STAFF RECOMMENDATION

1310 McKennie Avenue

January 20, 2021

Application: New Construction—Infill

SITE PLAN

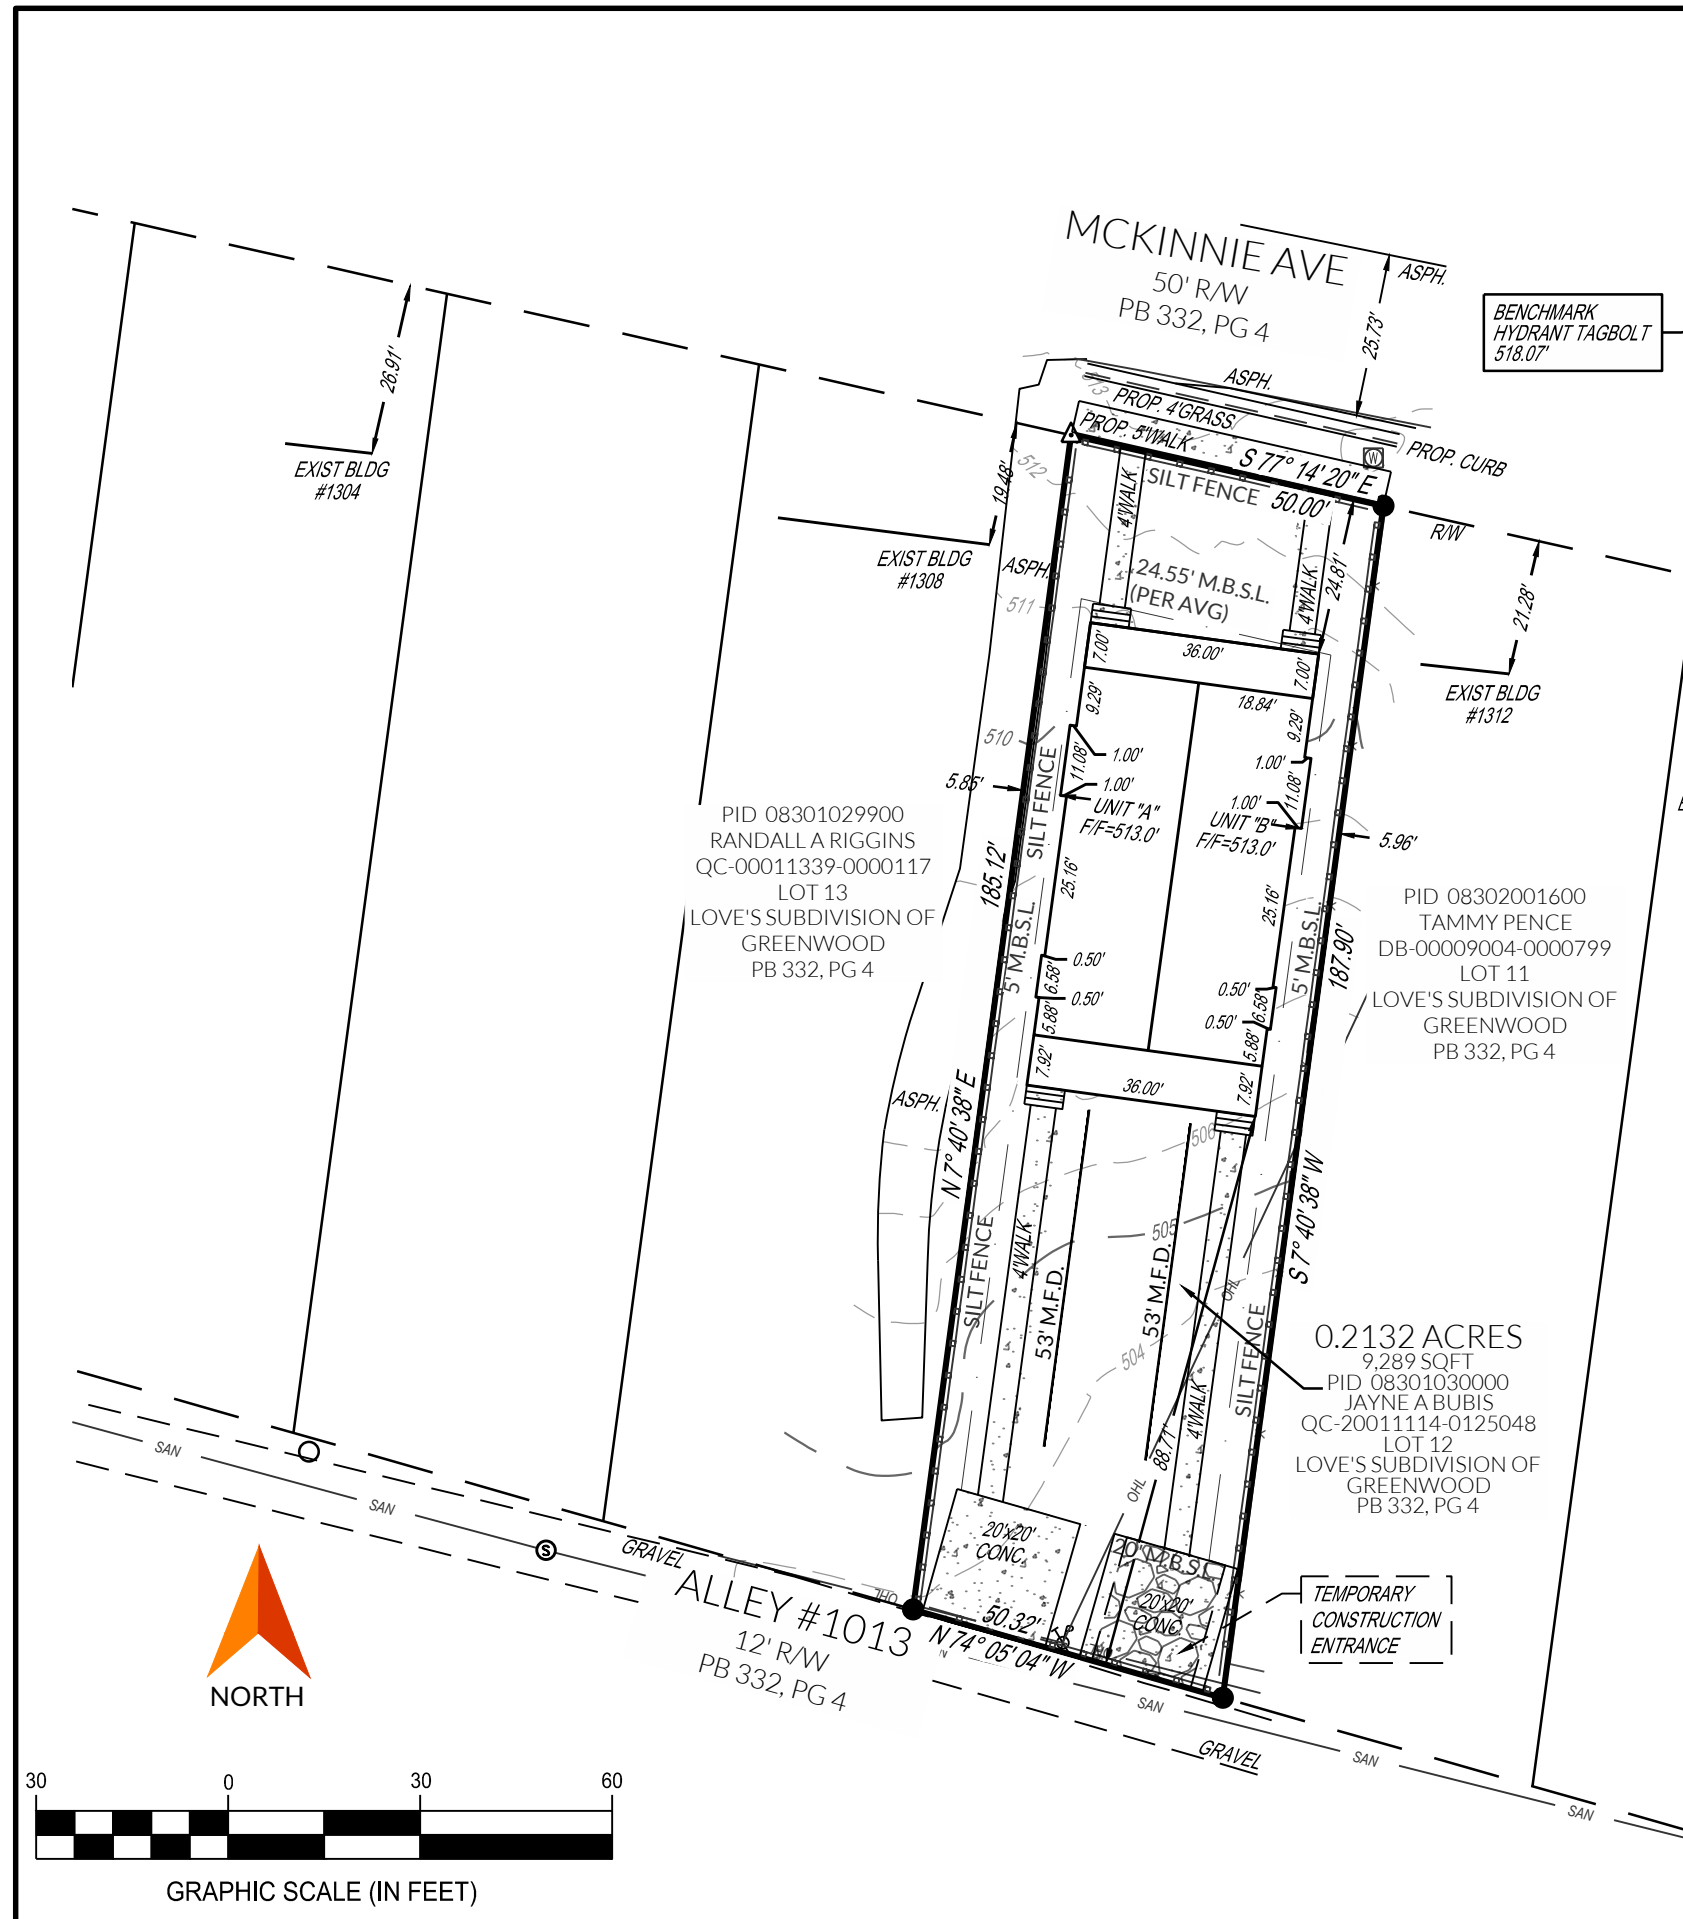
Setback & Rhythm of Spacing: The front setback is approximately twenty-four feet, ten inches (24'-10"), which sits a few feet farther back than the historic houses on either side. However, historic homes on this block face of McKennie Avenue have a wider range of front setbacks that range from approximately nineteen feet, six inches to thirty feet, six inches (19'-6" – 30'-6"). Given the historic context and the proposed two-story form, staff finds that the proposed front setback can be appropriate for this lot. The infill is located approximately six feet (6') from both side property lines and eighty-three feet

The previous house on the site included front yard parking. The proposed plan shows two uncovered parking pads to be accessed from the alley at the rear. The site plan does not show front yard parking, but staff recommends a condition to emphasize that front yard parking is not appropriate. The project meets Section II.B.1.i.

| SITE PLAN | |

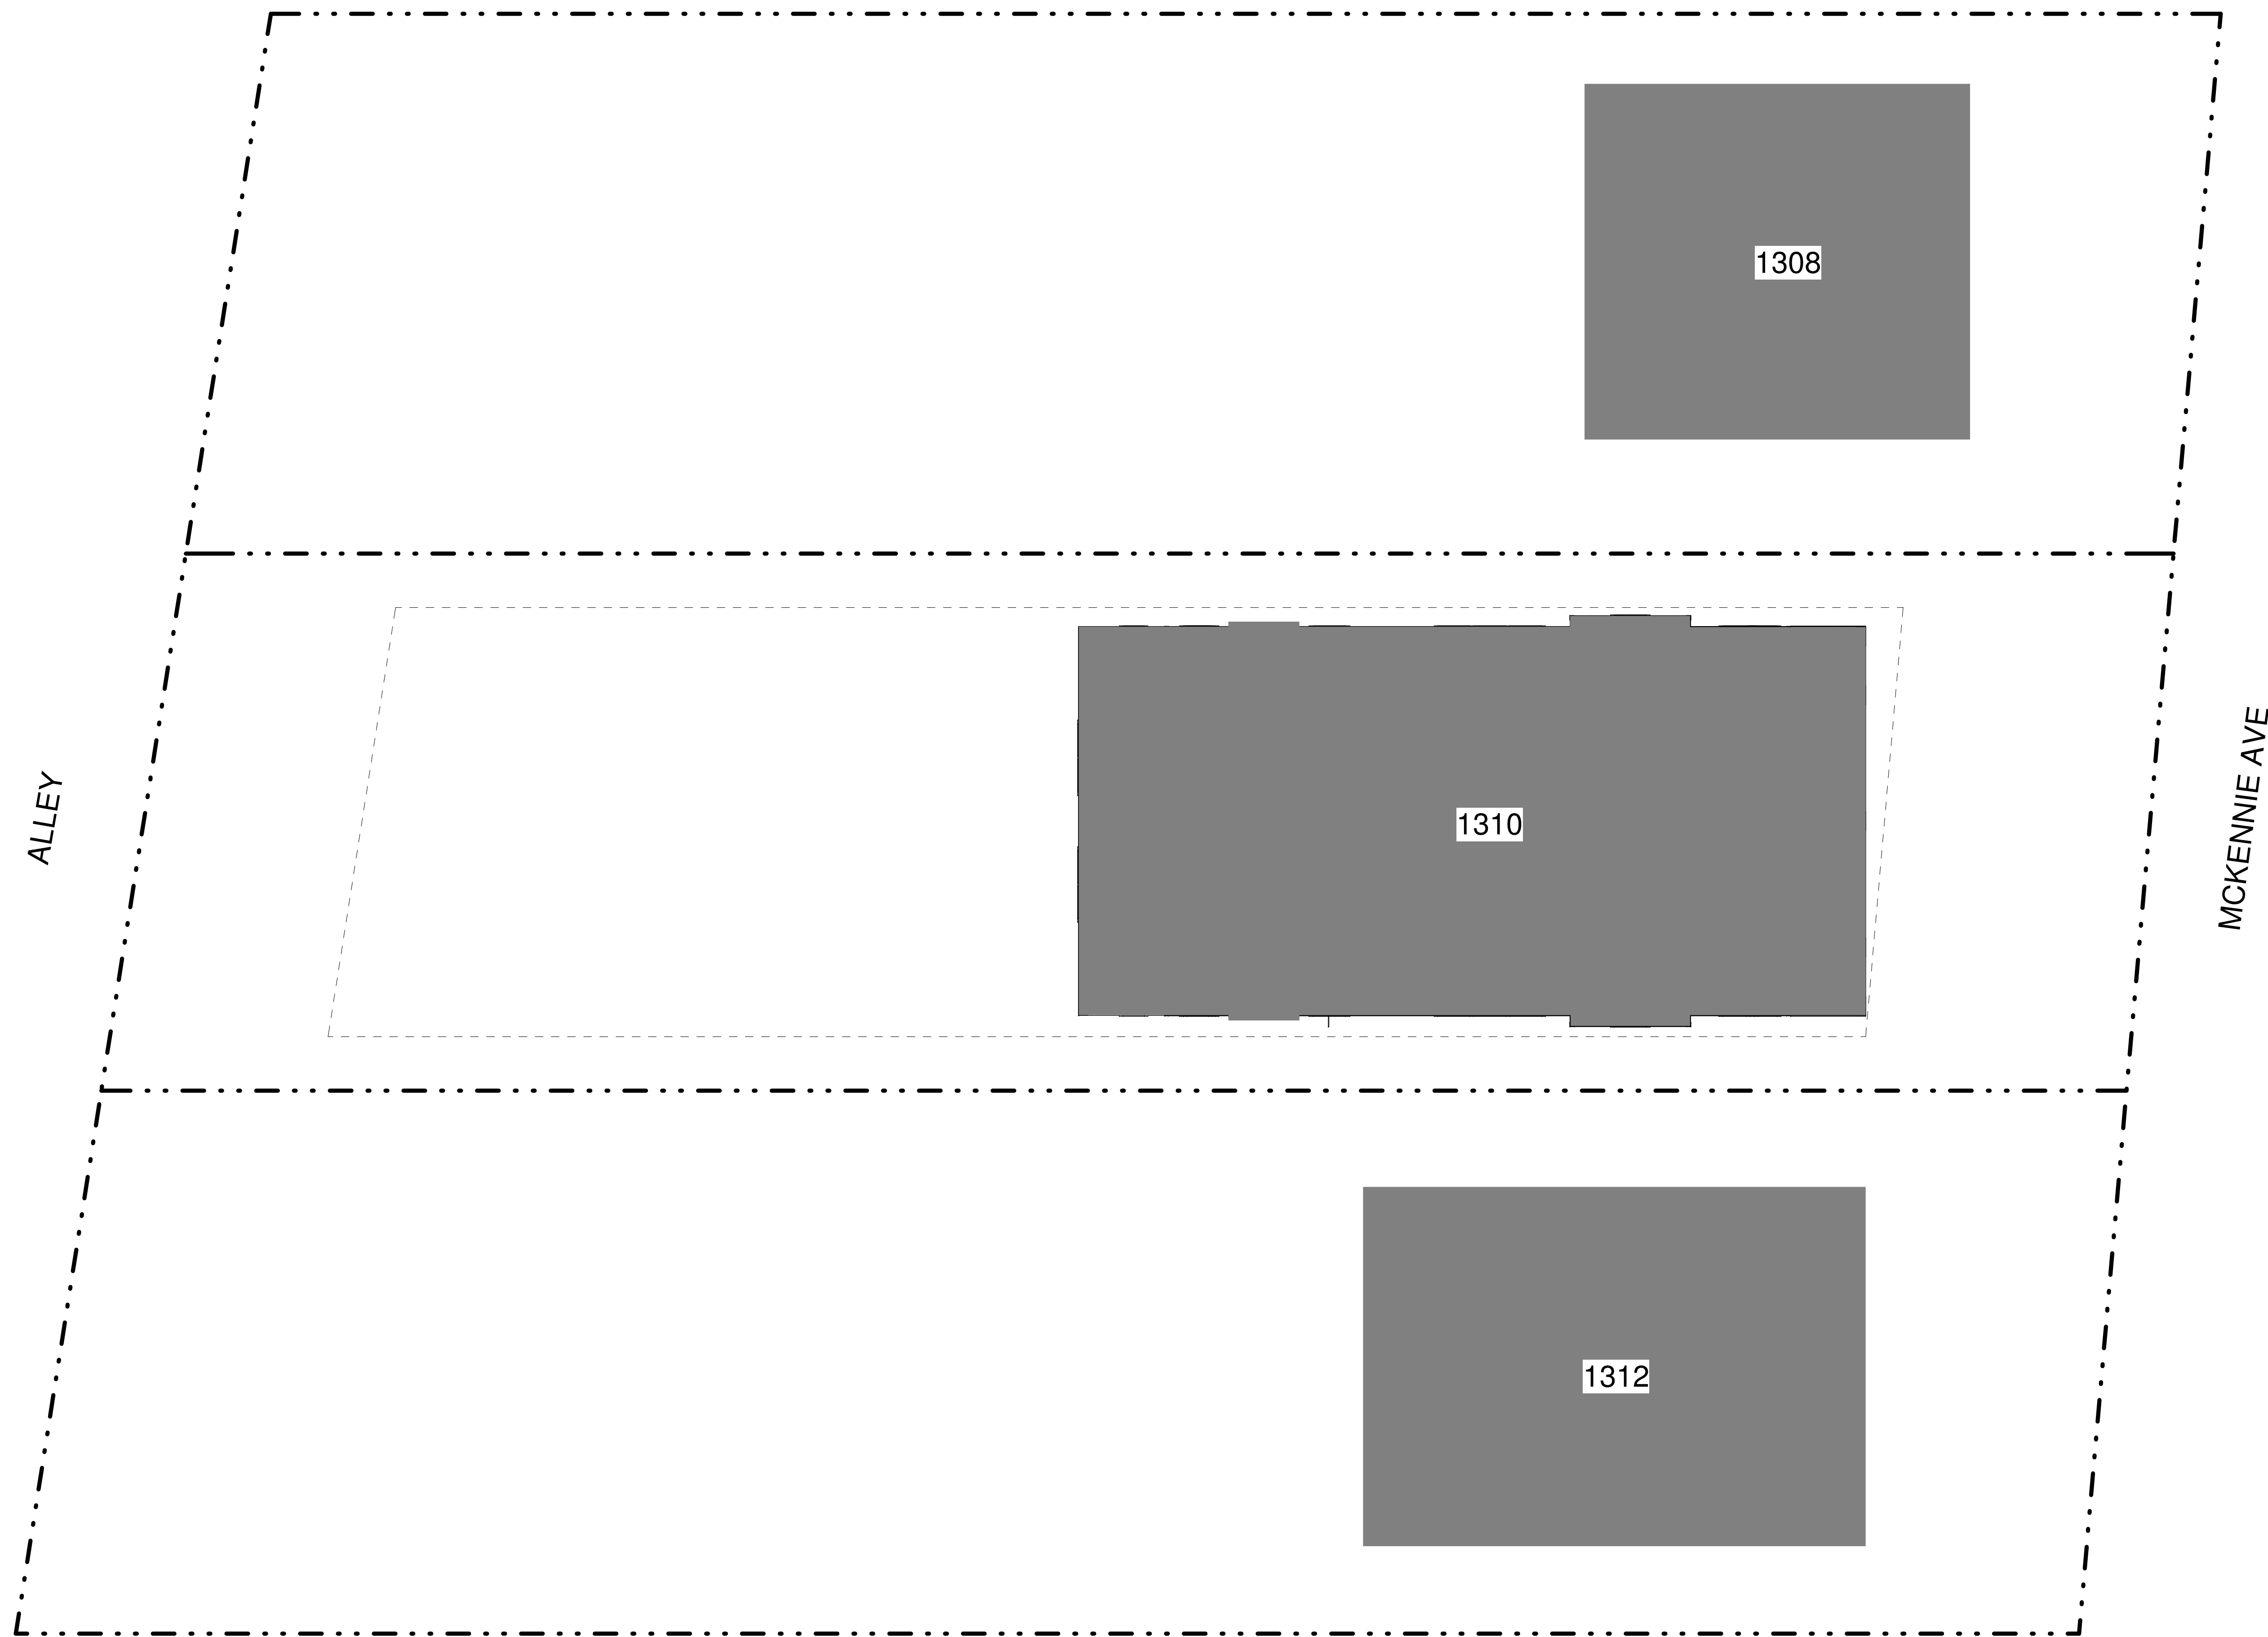
(83') from the rear property line. The project meets all base zoning setbacks and the setback and rhythm of spacing are appropriate for the historic context.

1. The finished floor height shall be consistent with the finished floor heights of the adjacent historic houses, to be verified by MHZC staff in the field;
2. The front setback shall be verified by MHZC staff in the field;
3. Staff approve the final details and dimensions of all unknown materials prior to purchase and installation;
4. Staff approve the masonry color, dimensions and texture;
5. The existing front yard parking shall be removed; and,
6. The HVAC shall be located behind the house or on either side, beyond the mid-point of the house, and utility meters shall be located on the side of the building, within 5' of the front corner. Alternative mechanical and utility locations must be approved prior to an administrative sign-off on building permit(s).
